Appl. No. : **10/728,103**
Filed : **December 4, 2003**

REMARKS

AMENDMENTS TO THE DRAWINGS

HIGH EFFICIENCY, MONOLITHIC MULTIJUNCTION SOLAR CELLS CONTAINING
LATTICE-MISMATCHED MATERIALS AND METHODS OF FORMING SAME

Figure 4.

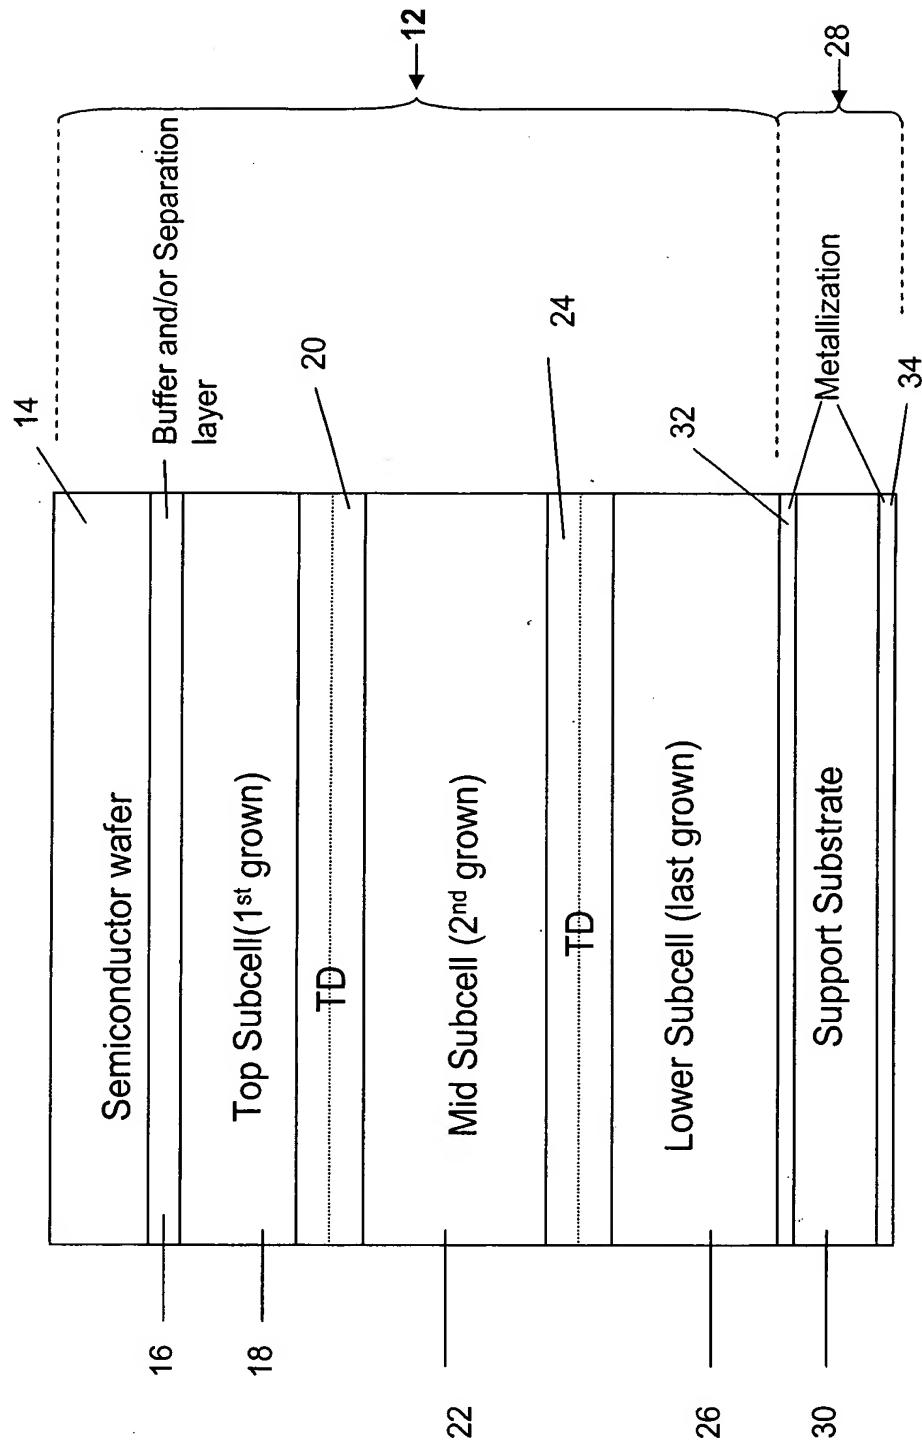
Additionally, Applicants have amended the drawings. In particular, in Figure 4, the reference numeral 12 is replaced with the reference number 40. The structure corresponding to reference numeral 12 is shown in Figure 1. No new matter is therefore added.

Dashed lines extending from the bracket associated with reference numeral 28 are also added. The structure corresponding to reference numeral 28 is shown in Figure 2. Accordingly, no new matter is added.

In Figure 4, please replace reference number 40 with reference numeral 12. Please also add dashed lines extending from the bracket associated with reference numeral 28.

Figure 5.

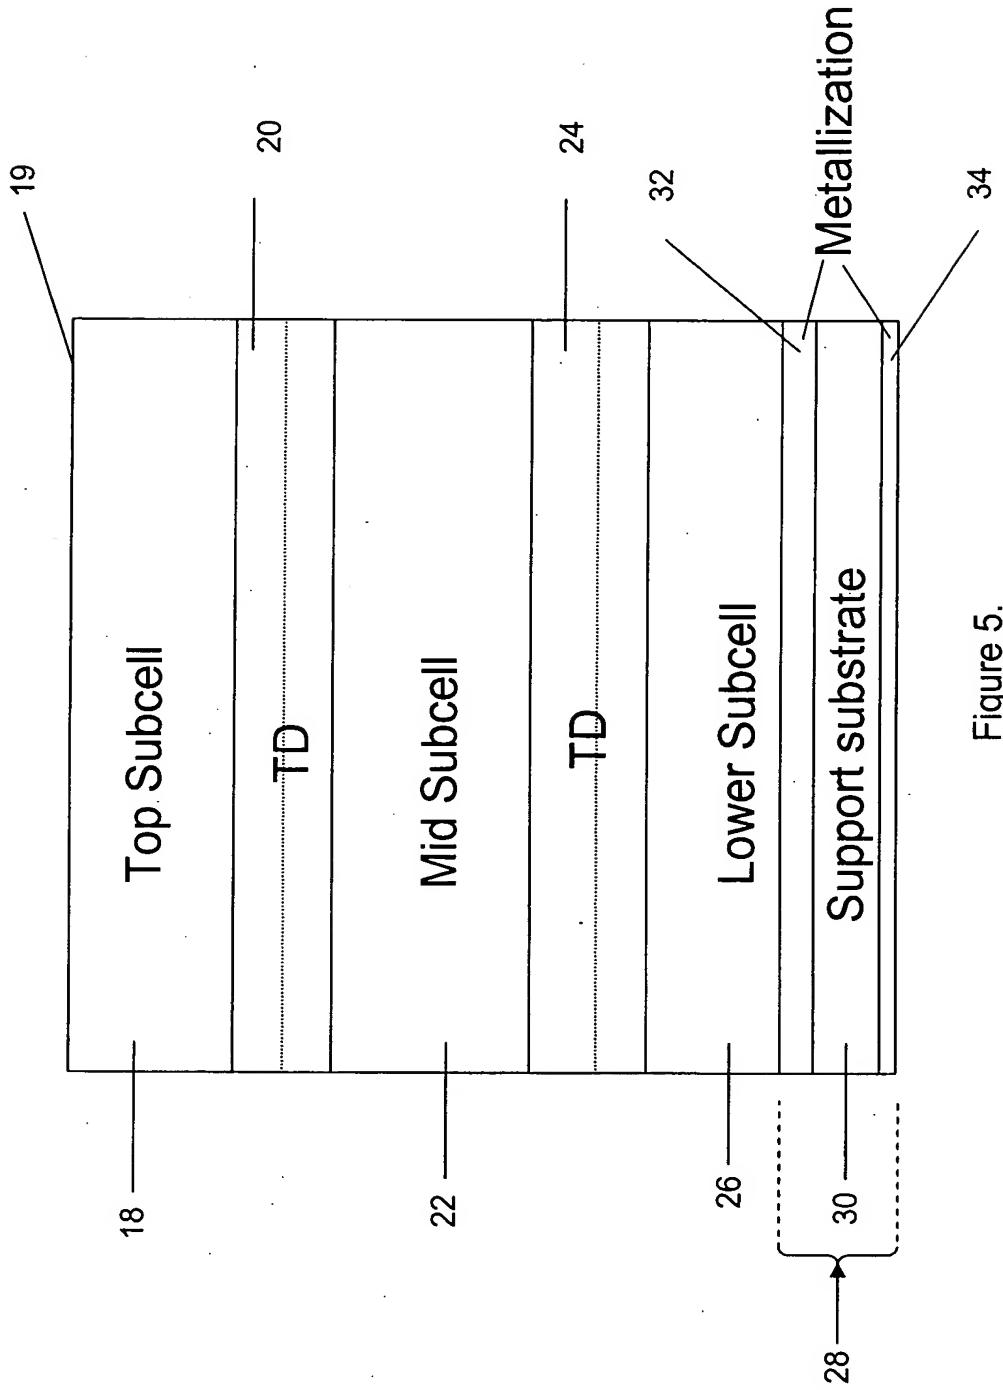
Similarly, in Figures 5, 6, and 9, a bracket and dashed lines extending from an arrow associate with reference numeral 28 is added. As discussed above, the structure corresponding to reference numeral 28 is shown in Figure 2, and thus, no new matter is added.

In Figure 5, please add a bracket and dashed lines extending therefrom at the end of the arrow associated with reference numeral 28.

Figure 6.

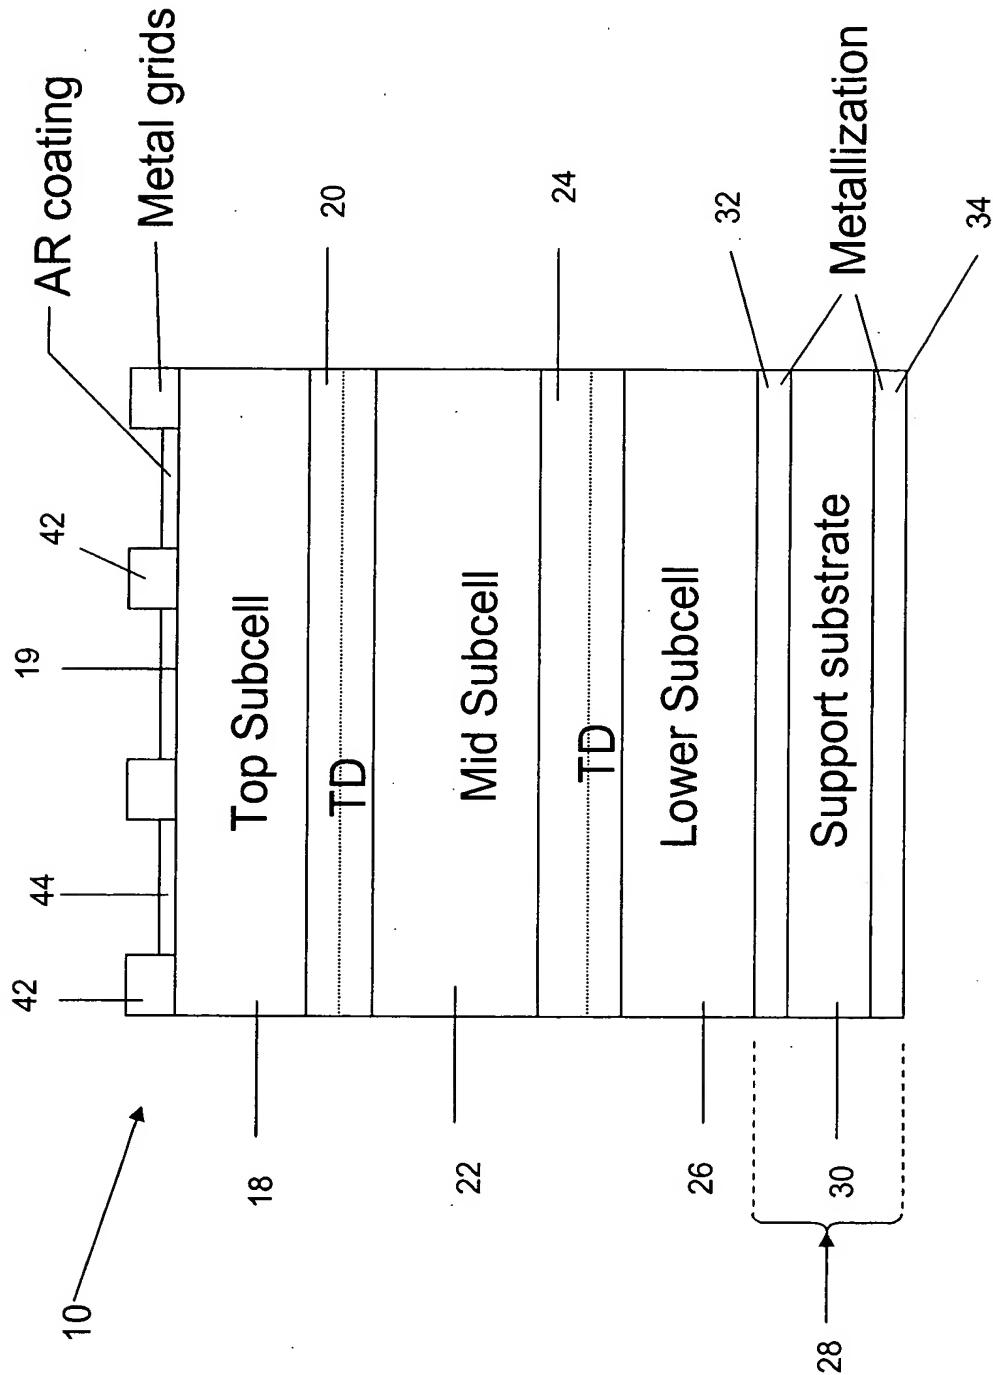
In Figure 6, please add a bracket and dashed lines extending therefrom at the end of the arrow associated with reference numeral 28.

Figure 9.

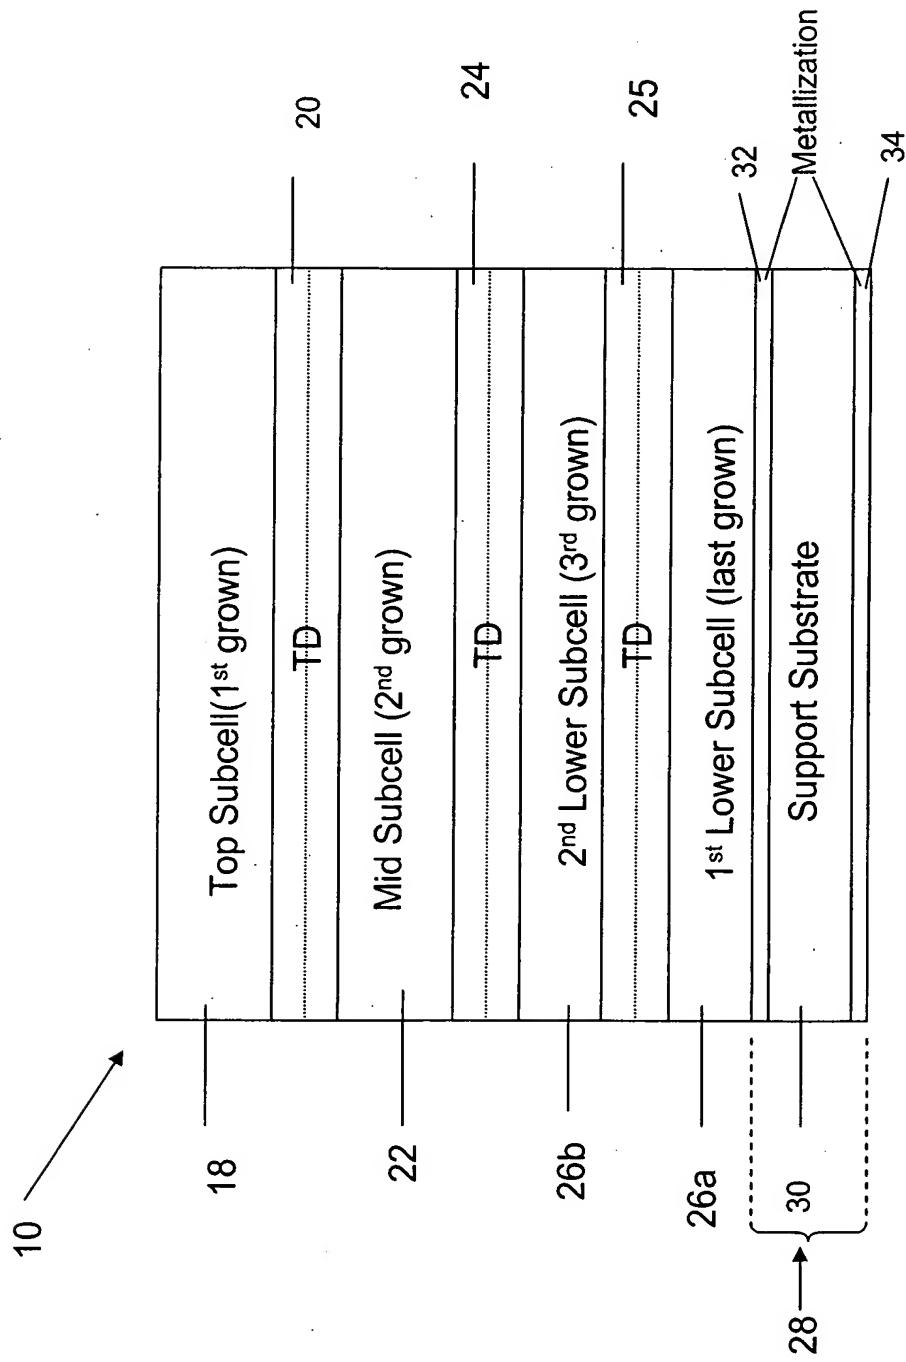
In Figure 9, please add a bracket and dashed lines extending therefrom at the end of the arrow associated with reference numeral 28.
